Addendum 137 – UN Regulation No. 138

Revision 1 - Amendment 1

Supplement 1 to the 01 series of amendments – Date of entry into force: 11 January 2020

Uniform provisions concerning the approval of Quiet Road Transport Vehicles with regard to their reduced audibility

"Figure 7b
Test procedures for measurement of frequency shift, Method A

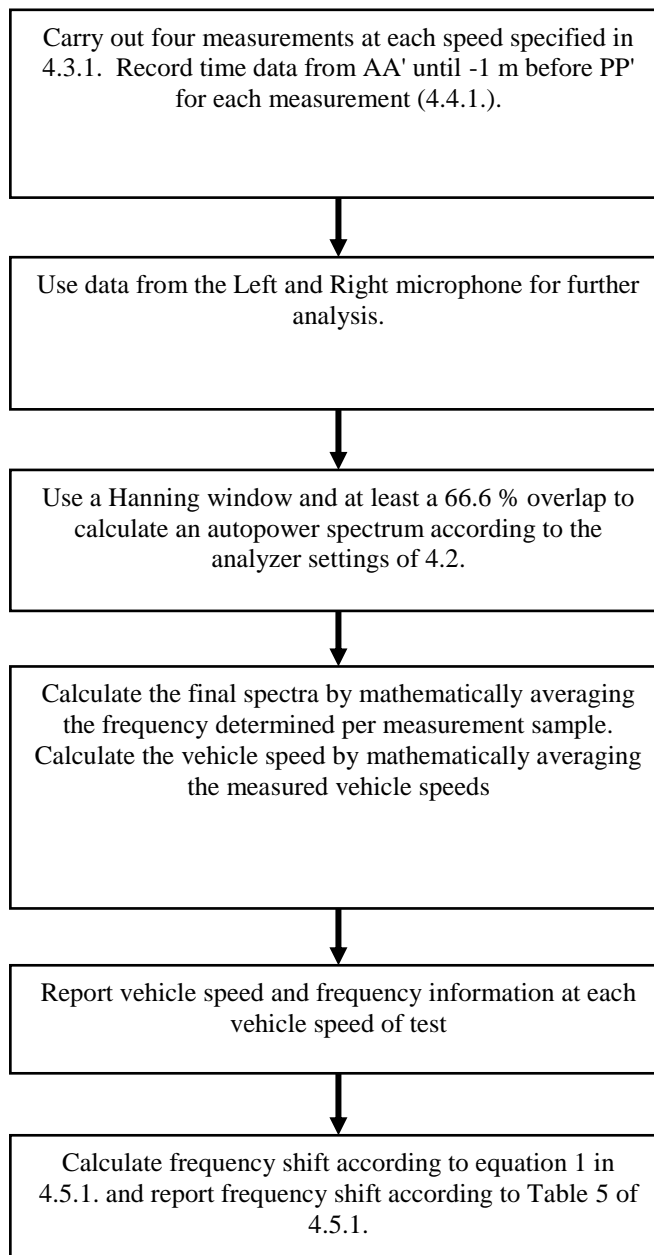
Figure 7b, amend to read:
